Our Case Number: ABP-314724-22

OBSERVATION LETTER

Application Title: Metrolink

Our observation relates primarily to the Mater station proposed in the MetroLink scheme. This station will be located in the heart of our community at a location of significant community amenity and historical value. While the community welcomes a metro station in the neighbourhood and the convenience this will bring, concerns exist regarding the design of the overground elements of the station and regarding the construction phase of the project.

Figure 1.1: Mater Station Alignment Plan – Reinstatement of Railings and Green Space

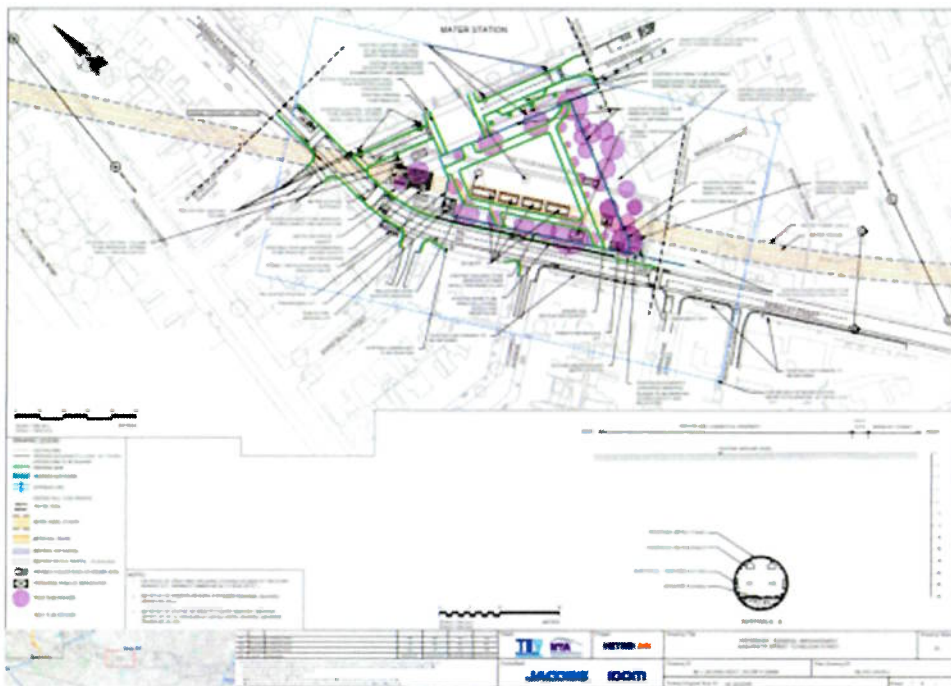
6. The plan provided by TII regarding reinstatement of railing length and green space (Four Masters Park. Railing Length and Green Space, Day 16: Book 1 of 1 (= Document 48. Letter from TII dated 19.03.24) is not legible (see below).

We therefore request a clearer, more legible version of this plan. We also request that a revised plan of the restored park taking all of the above concerns into account be provided.
